**TO:** CHIEF ADMINISTRATIVE OFFICER  
**FROM:** BRIGID REYNOLDS, CONSULTING TOWN PLANNER  
**SUBJECT:** DP2026-04 – 464 MOUNTAIN VIEW CR  
**MEETING DATE:** JANUARY 27, 2026  
**SUBJECT PROPERTY:** LOT 23, SECTION 6, RENFREW DISTRICT, PLAN VIP86003 (PID 027-742-679)

The purpose of this application is to approve a development permit for the construction of a single-family dwelling within the Hazard Lands Development Permit Area (DPA 2).

**ATTACHMENT 1  
SITE PLAN**

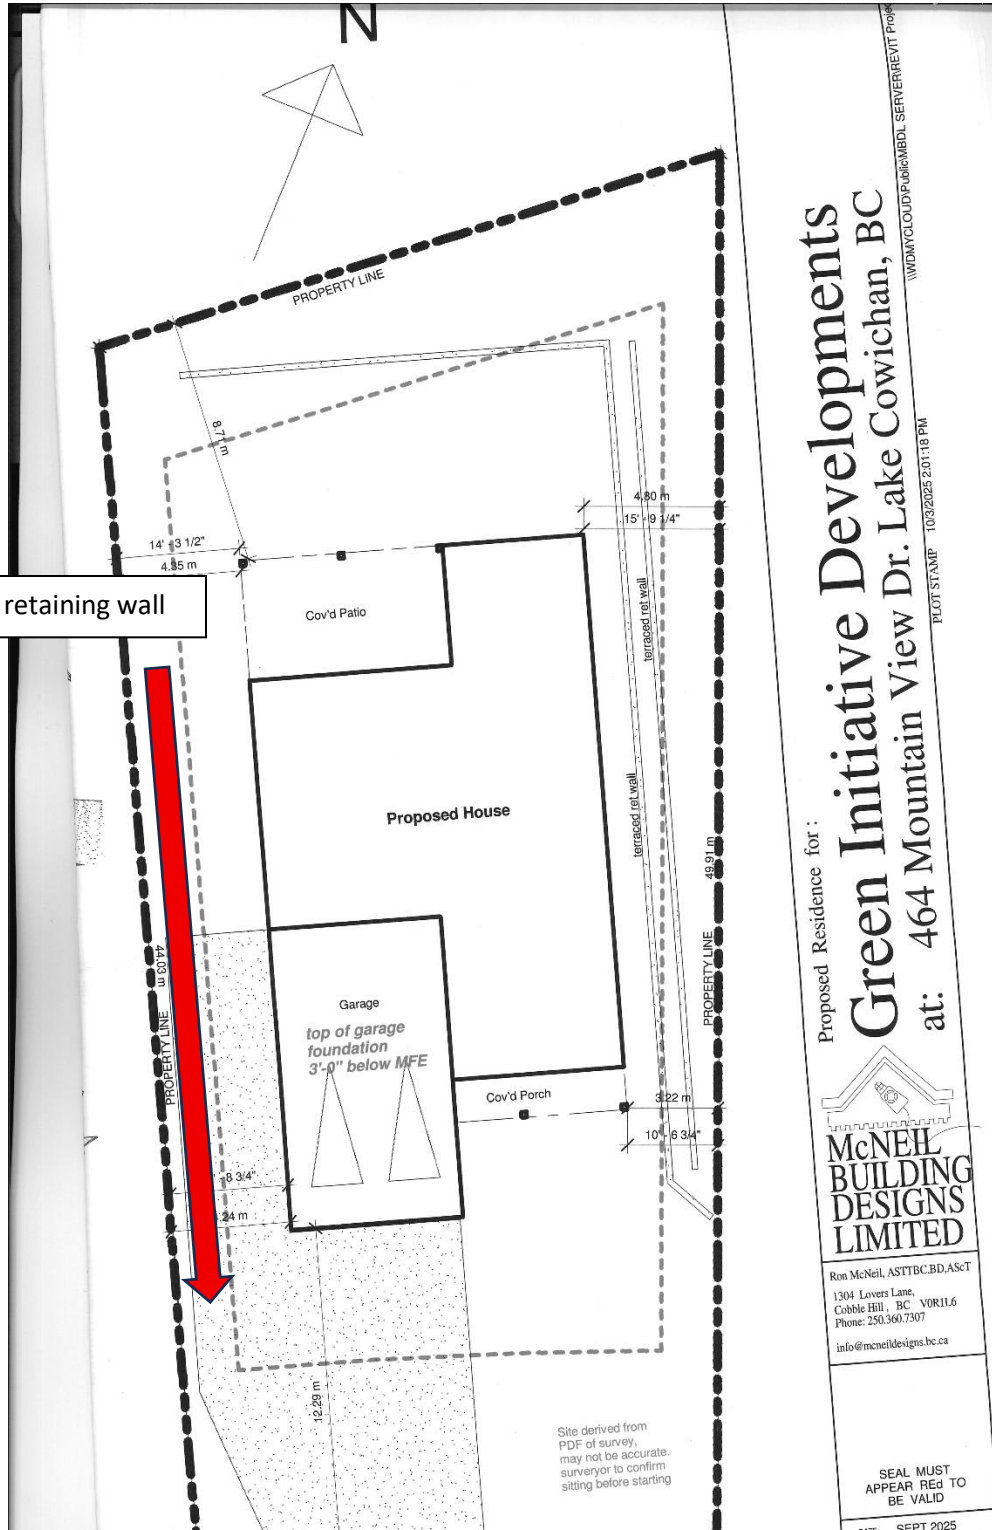
A 1.8 m tall stacked rock wall was constructed along the west property line without pre-approval from the Town and was not designed by the Geotechnical Engineer. The geotechnical report states these types of walls can be a rock fall hazard for downslope properties. The report states that stacked rock walls shall have a level (flat) 'no-build' rock fall zone along the based of the wall with a minimum lateral distance equal to the wall height. This stacked retaining wall is not shown on the site plan but its general location has been added by the planner.

The site plan shows additional retaining walls are proposed to be constructed along the east and north side of the property. The submitted drawings show these walls range in height and some appear to measure more that 1.2 m (4 ft). The geotechnical report notes that all retaining walls over 1.2 m in height must be designed by the Geotechnical Engineer. Additionally, Section 4.3.8 of the Zoning Bylaw states the maximum height of retaining walls is 2.0 m. Any proposed retaining wall over 2.0 m in height are not permitted and would require a development variance permit prior to construction.

Unpermitted 1.8 m retaining wall

The geotechnical engineer has confirmed that this stacked retaining rock wall does meet the requirements. The applicant has stated that this wall will be removed prior to any other land alteration. Approval to remove this retaining wall forms the first phase of this development permit.

1. Prior to issuing DP2026-04 the applicant shall provide additional requested information regarding the Wildfire Hazard Assessment report prepared by Inwood Forestry.
2. Prior to any land alteration and building permit issuance:
  - a. Register a section 219 covenant including a save harmless clause and the Geotechnical Hazard Assessment prepared by Lewkowich Engineering, dated January 8, 2026 on the certificate of title.
  - b. Implement sediment and erosion control measures to prevent sediment from leaving the site and entering the Town's stormwater system.
3. Following confirmation of the registration of the Section 219 covenant, the first land alteration action shall be to remove stacked retaining wall along the west property line.
4. All development shall be in accordance with
  - a. Attached site plan
  - b. Any retaining wall over 2.0 m in height are not permitted.
